Docket Nos. 50-280
and 50-281

Tech. Spec. Change No. 6
License Nos. DPR-32
and DPR-37

UNITED STATES
ATOMIC ENERGY COMMISSION
WASHINGTON, D.C. 20545

Tech. Spec. Change No. 6
License Nos. DPR-32
and DPR-37

FIGURE 2.1-1
SAFETY LIMITS REACTOR CORE
THERMAL AND HYDRAULIC, THREE
LOOP OPERATION, 100% FLOW

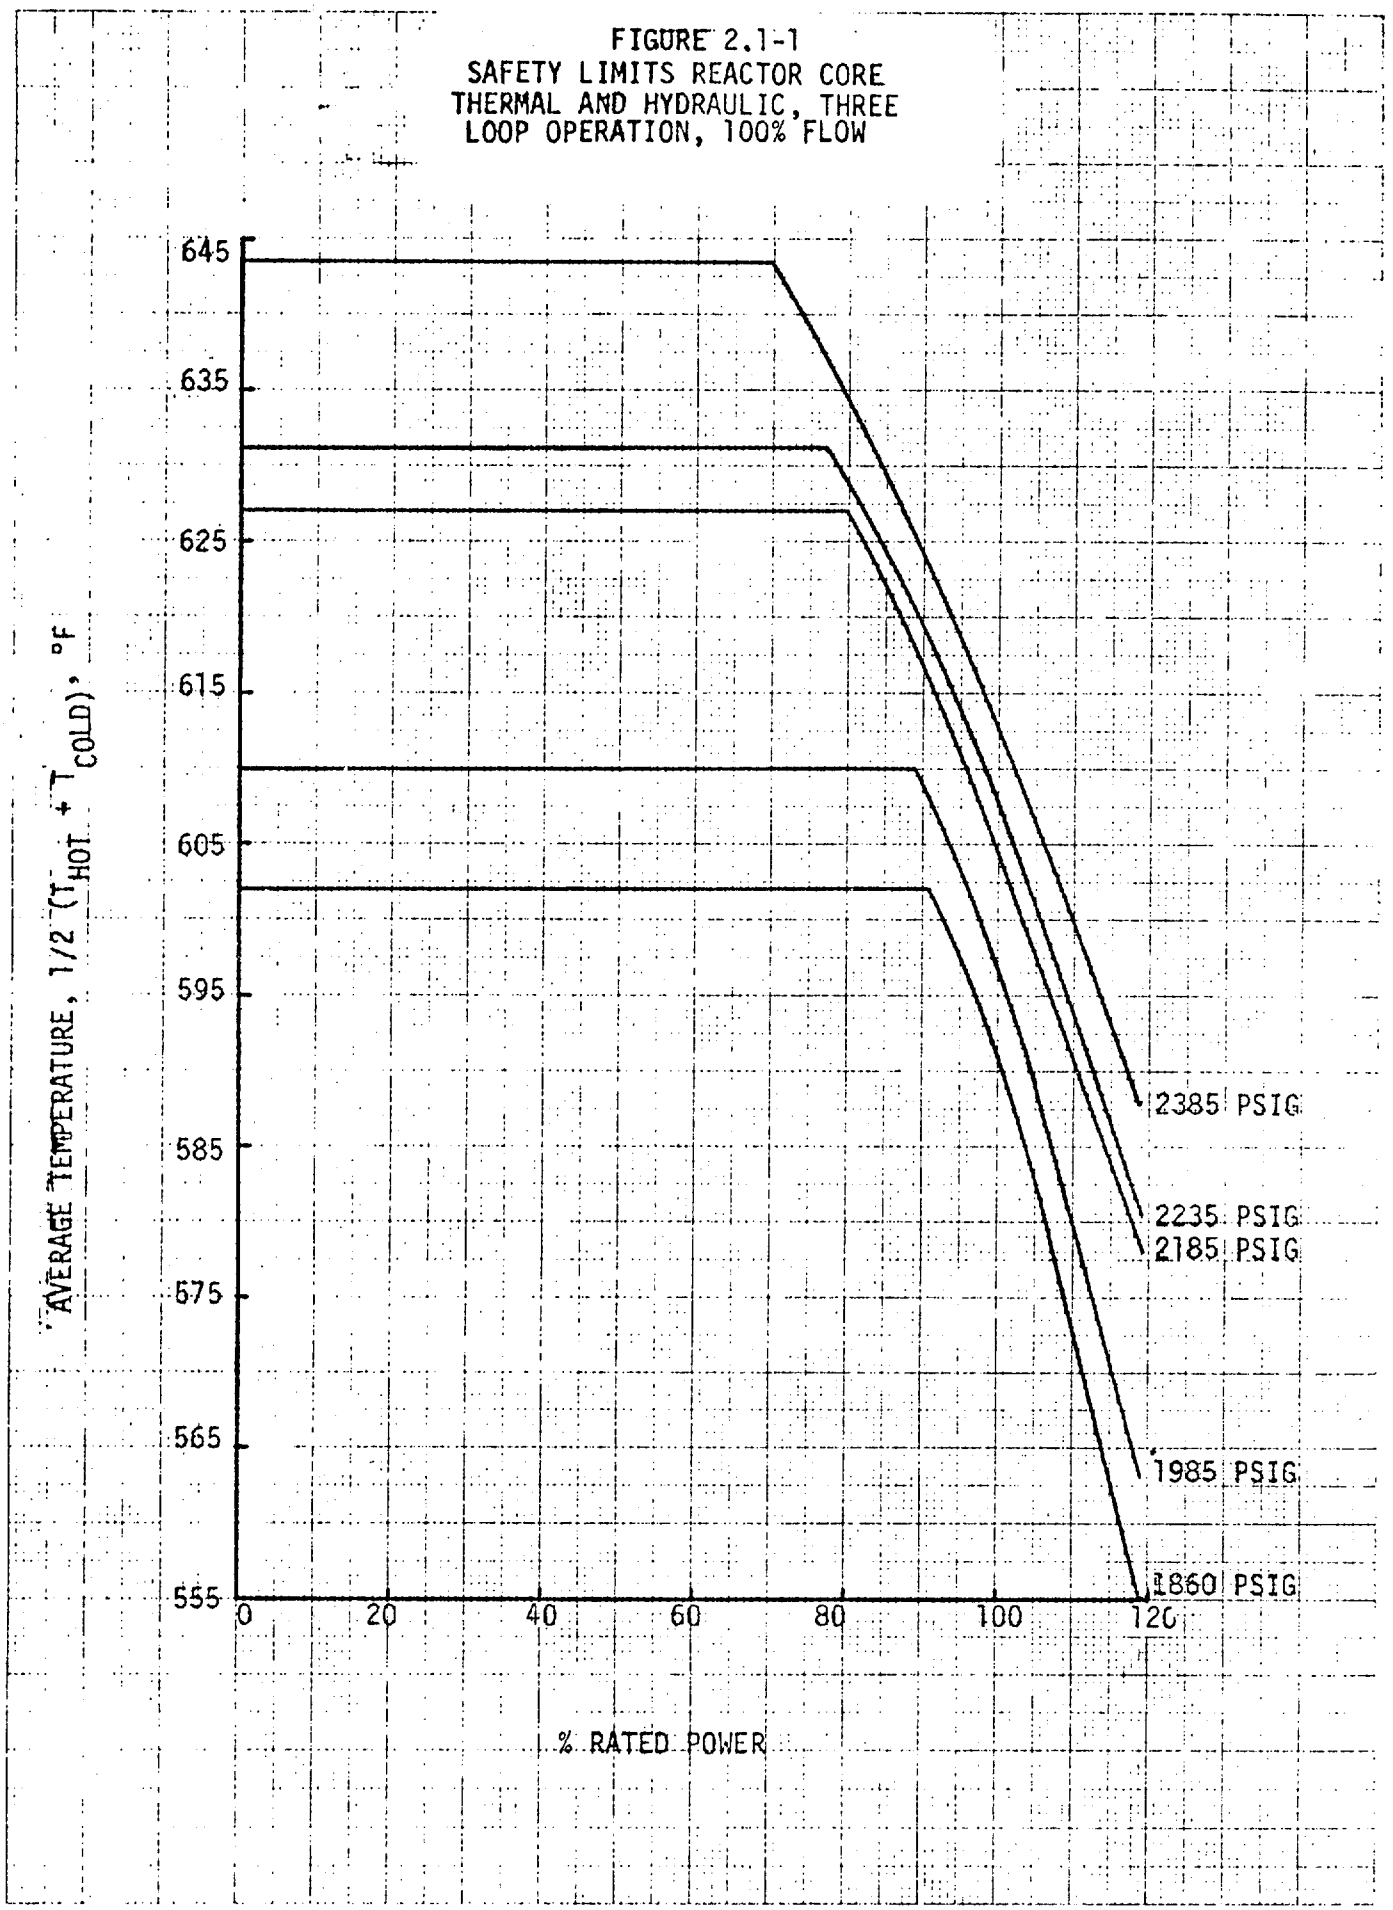
The curves of TS Figure 2.1-1 which show the allowable power level decreasing with increasing temperature at selected pressures for constant flow (three loop operation) represent the loci of points of thermal power, coolant system average temperature, and coolant system pressure for which the DNB ratio is not less than 1.30. The area where clad integrity is assured is below these lines. In order to completely specify limits at all power levels, arbitrary constant upper limits of average temperature are shown for each pressure at powers lower than approximately 75% of rated power. The temperature limits at low power are considerably more conservative than would be required if they were based upon a minimum DNB ratio of 1.30 but are such that the plant conditions required to violate the limits are precluded by the self actuated safety valves on the steam generators. The three loop operation safety limit curve has been revised to allow for heat flux peaking effects due to fuel densification. 6

The overpower and overtemperature protection system setpoints have been revised to include effects of fuel densification on core safety limits. The revised setpoints in the Technical Specifications will ensure that the combination of power, temperature, and pressure will not exceed the revised 6

core safety limits as shown in Figures 2.1-1, 2, and 3. | 6

FIGURE 3.12-1

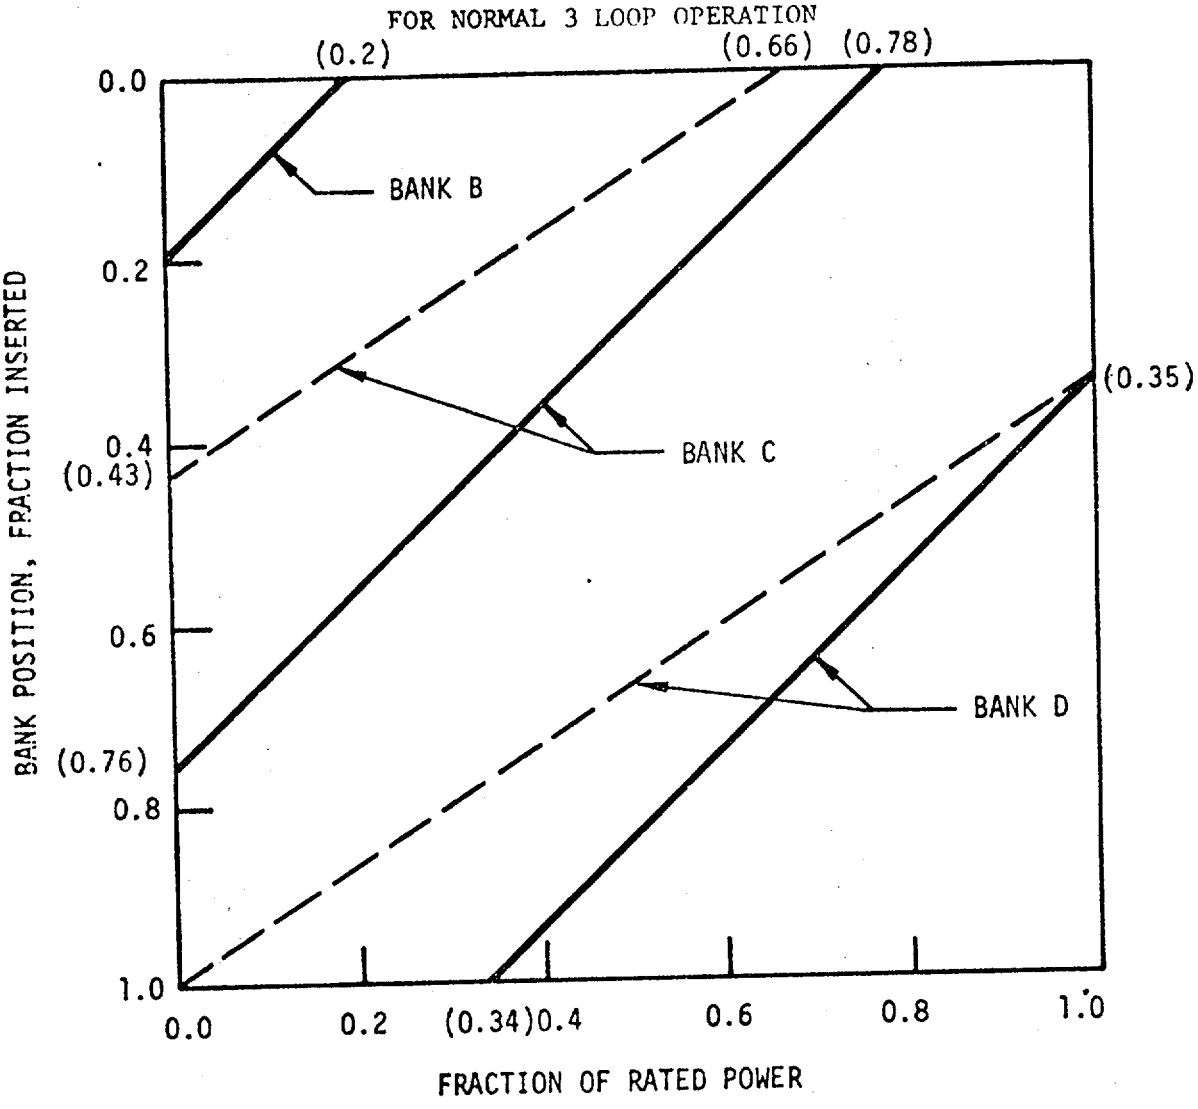
The specified control rod insertion limits have been revised to limit the potential ejected rod worth in order to account for the effects of fuel densification. 6

Figure 3.12-8
Densification Power Spike
Penalty Factor

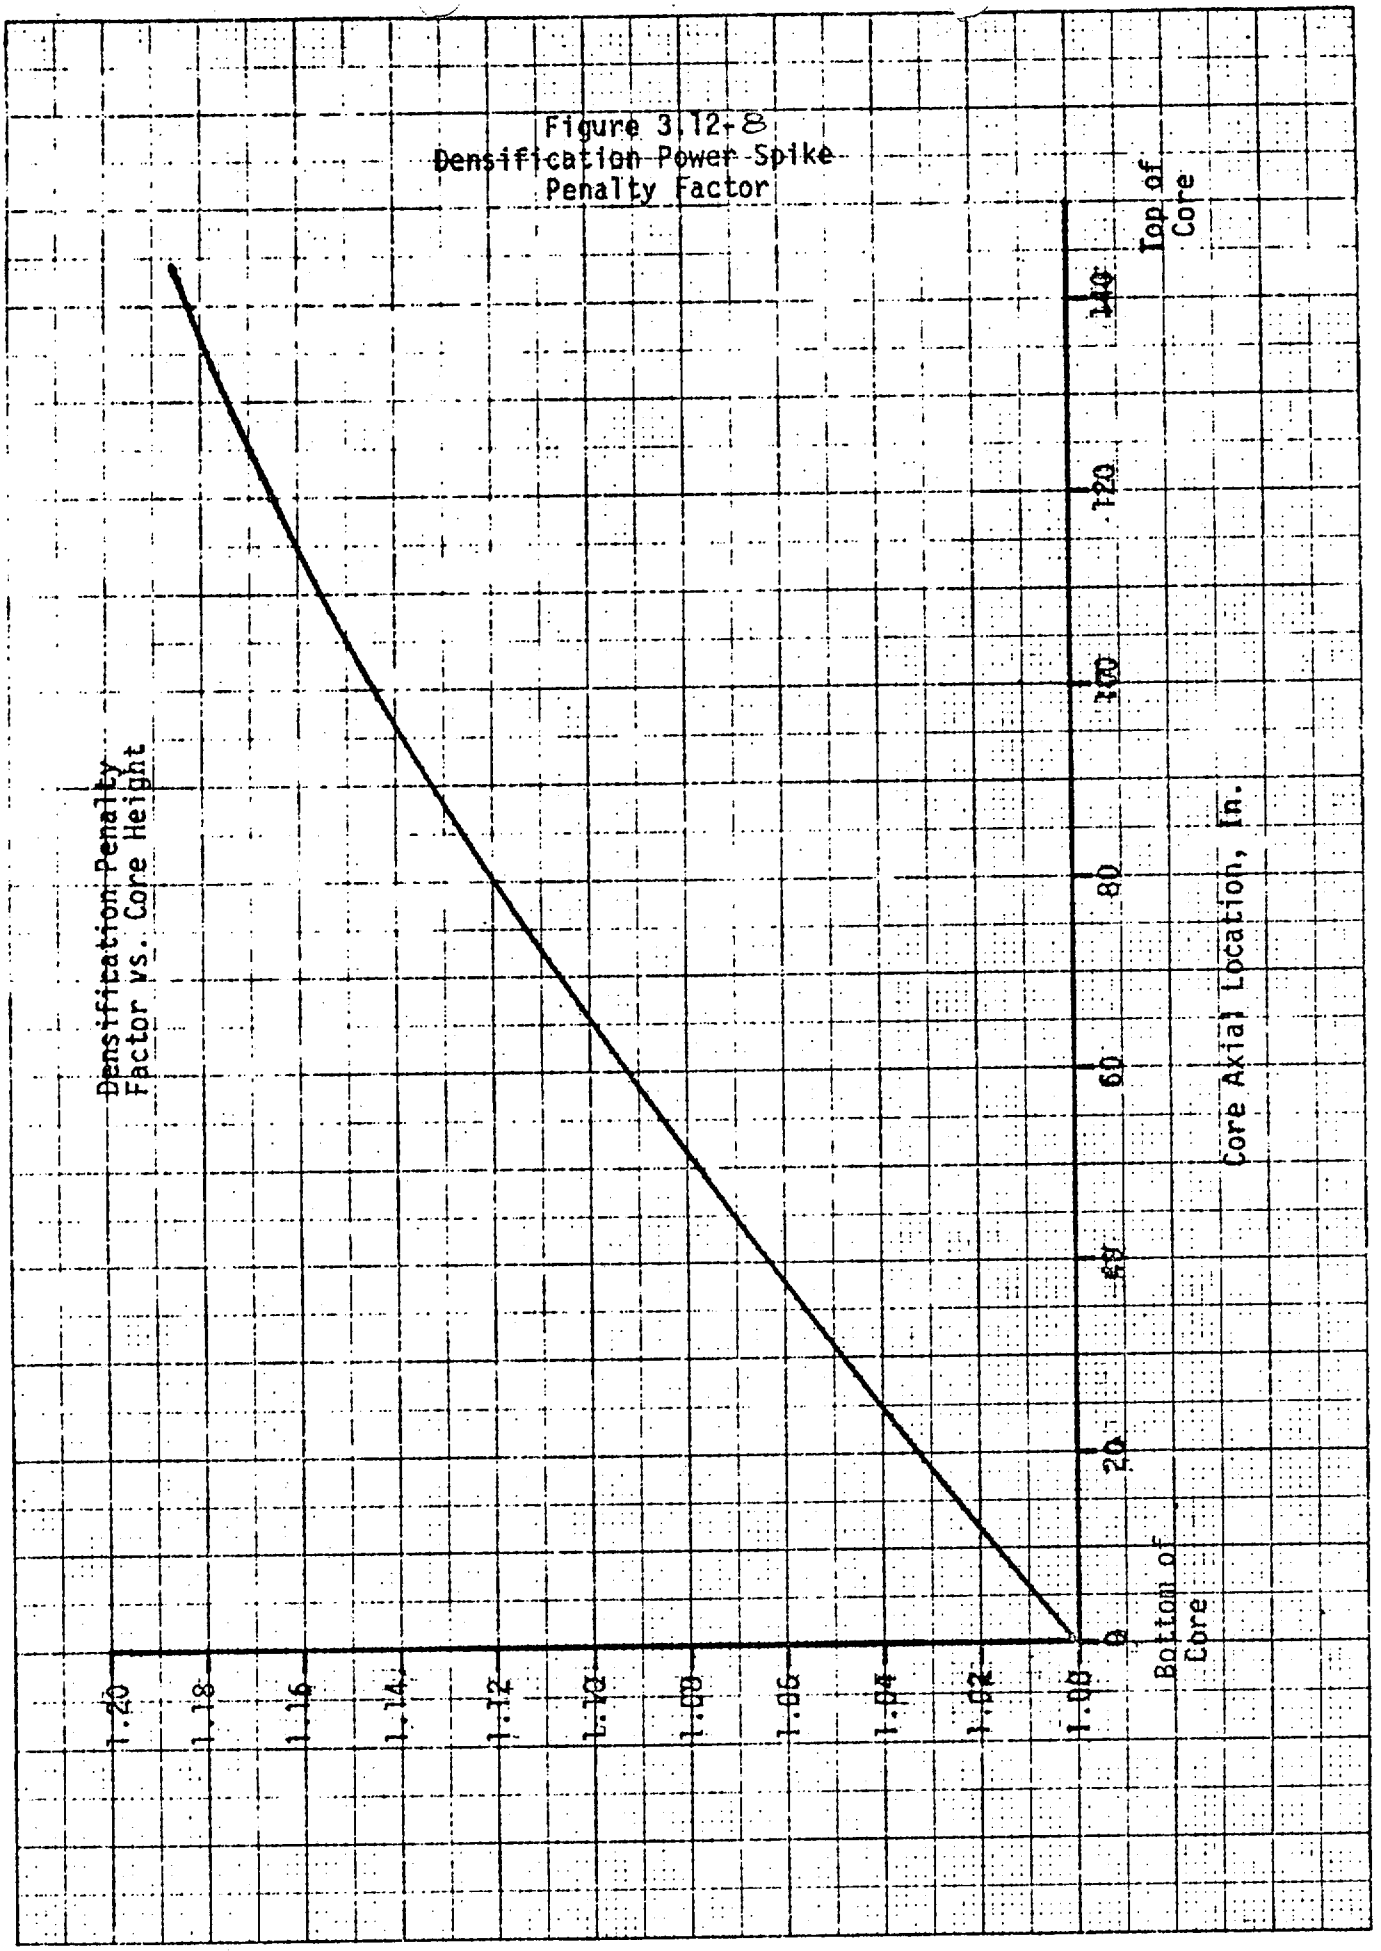
The measured value of F_Q^N must be additionally corrected by including a penalty as shown on Figure 3.12-8 (at the appropriate core location) to account for fuel densification effects before comparison with the limiting value above.

(1) Two traverses with the movable in-core detectors in appropriate alternate pairs of channels shall be taken every eight hours, or at a frequency of 0, 30, 60, 120, 180, 240, 360, and 480 minutes following accumulated control rod motion of five steps except for control rod exercises limited to within 10 steps from the top of the core. From the traverses, determination that $F_Z^N \leq 1.60/S(Z)$ where $S(Z)$ is the densification penalty factor as a function of core height shown in Fig. 3.12-8. This allows 4% measurement error.
